From: [Joel Geier](#)
To: [Coffin Butte Landfill Appeals](#)
Subject: LU-24-027 testimony (revised version of Oct 7th submission)
Date: Wednesday, October 8, 2025 12:36:03 PM
Attachments: [Hydro Comments Joel Geier 2025-10-07 revised 10-08.pdf](#)

Thank you for this opportunity to provide testimony regarding LU-24-027. My address is 38566 Hwy 99W, Corvallis OR 97330. I ask you to uphold the careful and thoroughly considered decision of the Benton County Planning Commission, to deny this permit application.

2) Brief comments on applicant's new claims in their Exhibit 67

Annex 1: Detailed information regarding groundwater issues

Figure 3. Arsenic and chloride levels in compliance-boundary wells MW-26 and MW-27 as plotted by VLI's consultants in Exhibit 49. Note that chloride is plotted in milligrams per liter (parts per million) while arsenic is plotted in micrograms per liter (parts per billion).

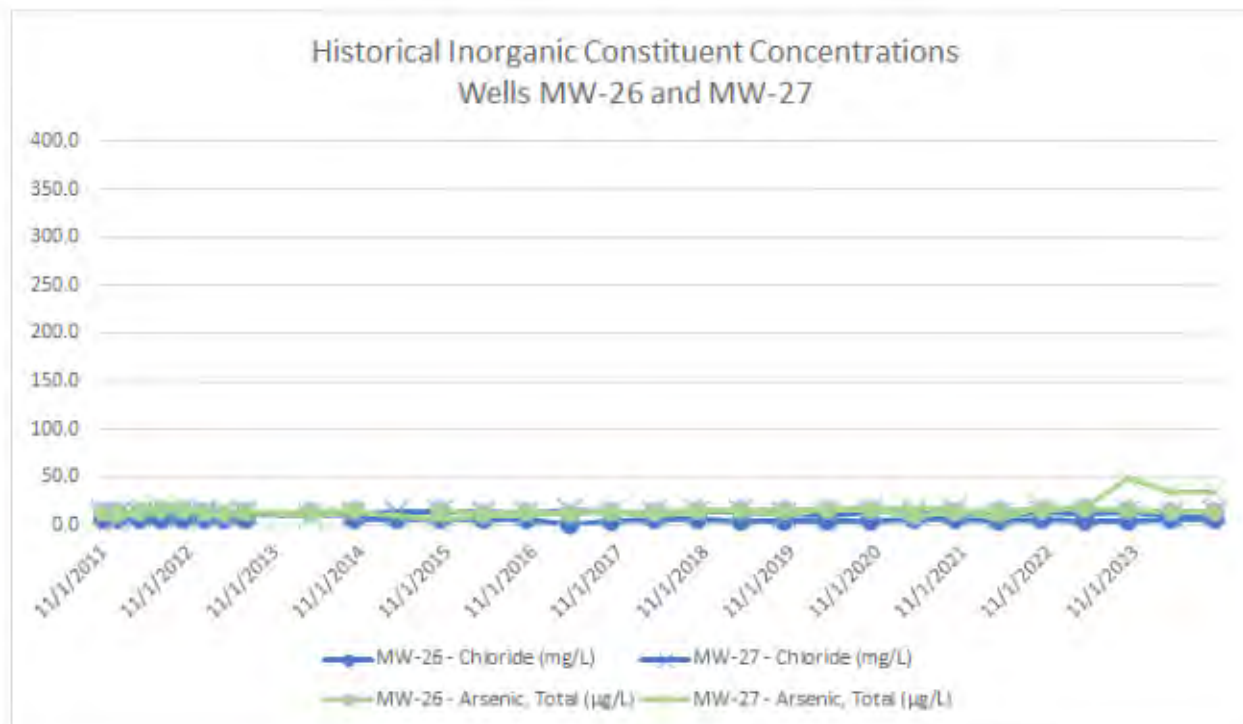
Note that the first plot in Exhibit 49 shows no arsenic measurements above 50 micrograms per liter ($\mu\text{g/L}$), but values up to 68 $\mu\text{g/L}$ have been measured in a nearby well more recently. VLI's consultants are certainly aware of those recent high values.

VLI notes that lower chloride levels are seen in the two compliance-boundary wells, MW-26 and MW-27, but this does not necessarily rule out that the high levels of arsenic observed in those wells could come from ongoing or past leaks.

Figure 4. Arsenic concentrations in east-side monitoring wells as plotted in the 2024 Annual Environmental Monitoring Report for Coffin Butte Landfill (obtained by a public-records request from ODEQ).

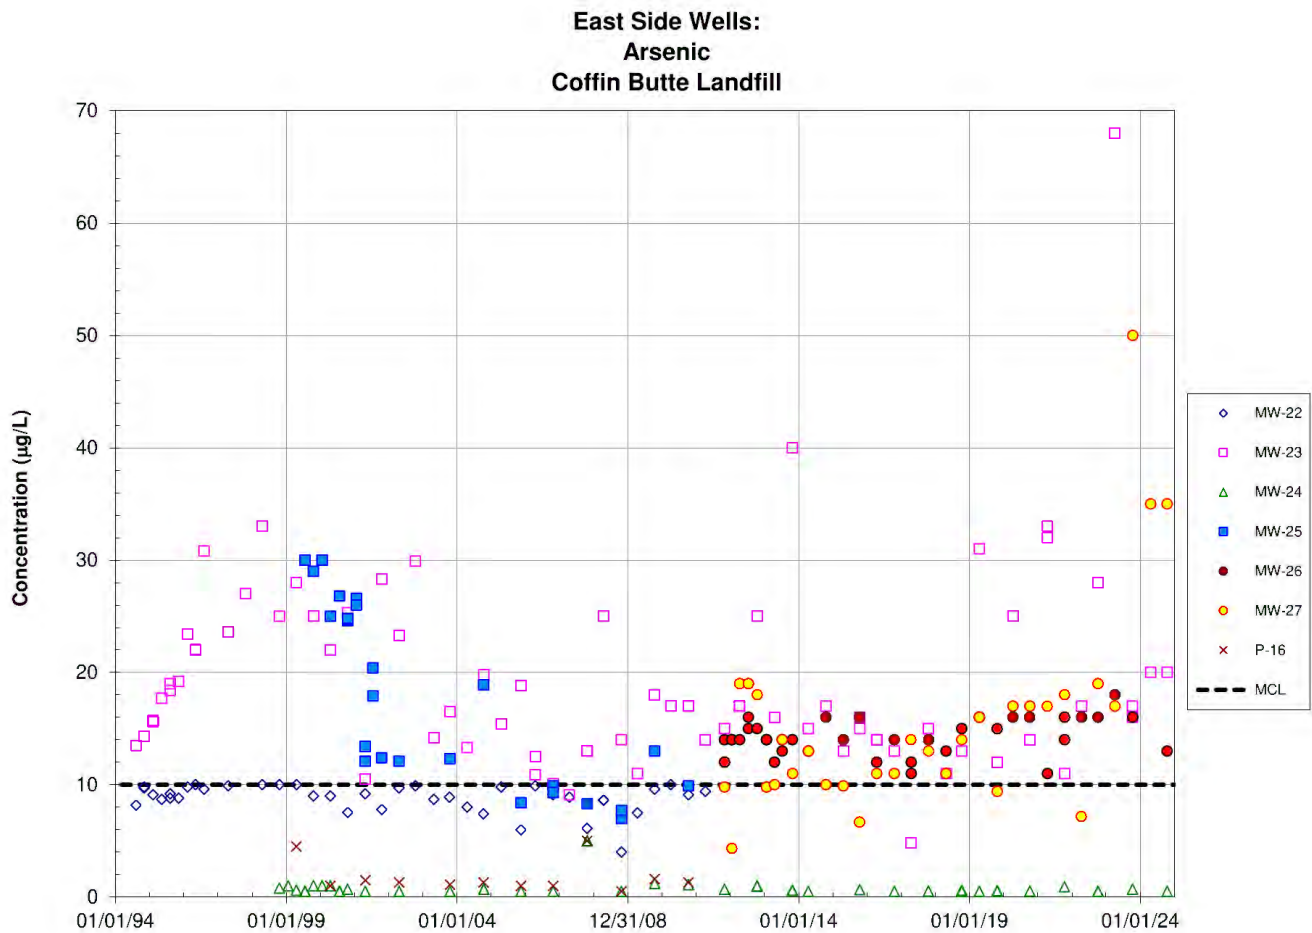
VLI's presentation of data from monitoring wells at Coffin Butte is also misleading. In presenting historical data on arsenic at Coffin Butte, they misleadingly plot data on a strangely chosen scale, with a maximum 10 times the range of the data (Figure 3). The effect is to conceal the strong fluctuations over time which are evident in a more scientifically reasonable presentation of the same data, as used in their Annual Environmental Monitoring Reports (Figure 4).

Figure 5. Arsenic and chloride levels in MW-9S as plotted by VLI's consultants in Exhibit 49.

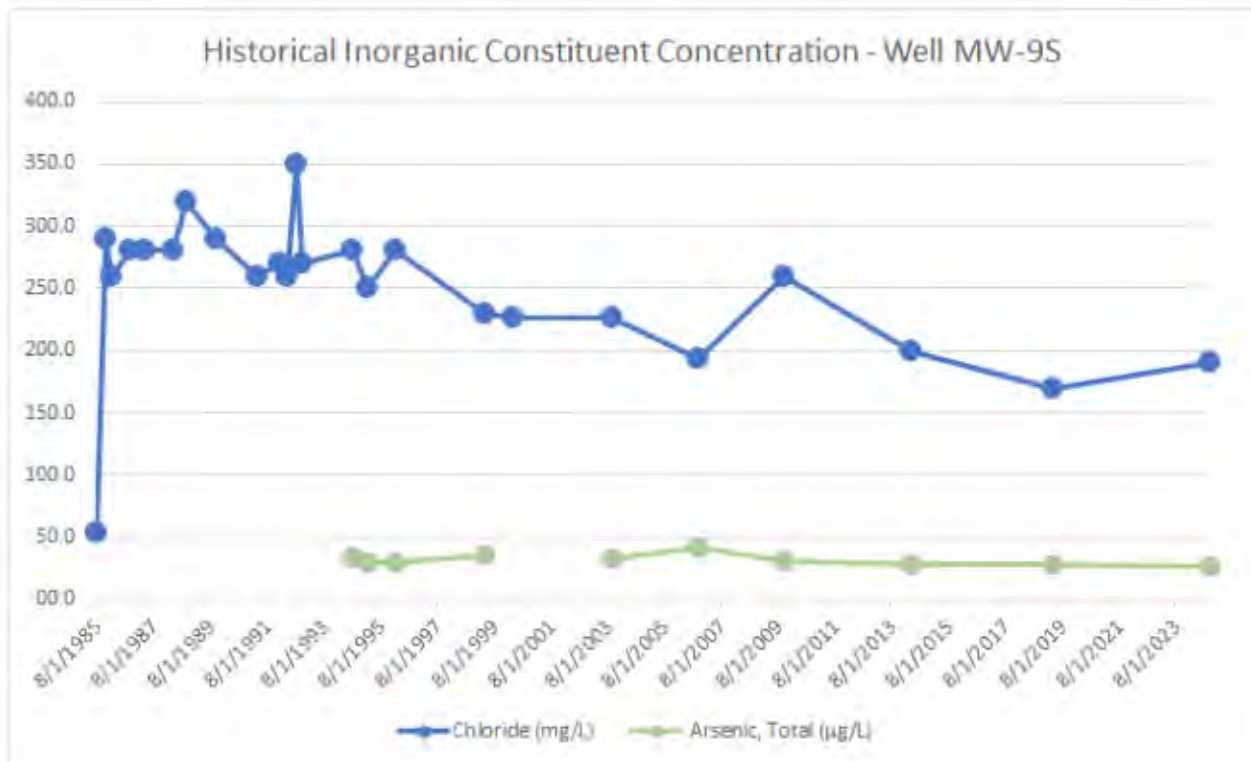
In the applicant's attempt to defray concerns about arsenic, they suggest that chloride is a better indicator. The second plot in Exhibit 49 (reproduced here as Figure 5) shows that the initial measurement of chloride in MW-9S was about 50 mg/L, but soon afterward the concentration jumped by nearly a factor of 6.

Though this declined somewhat after the seepage problem was discovered in the mid-1990s, and corrective actions were taken, chloride in MW-9S has remained more than a factor of 3 above the initial baseline value, ever since. Far from alleviating concerns about leakage from Cell 2, this plot elevates concerns about potential for ongoing contamination of the Willamette Basin aquifer.
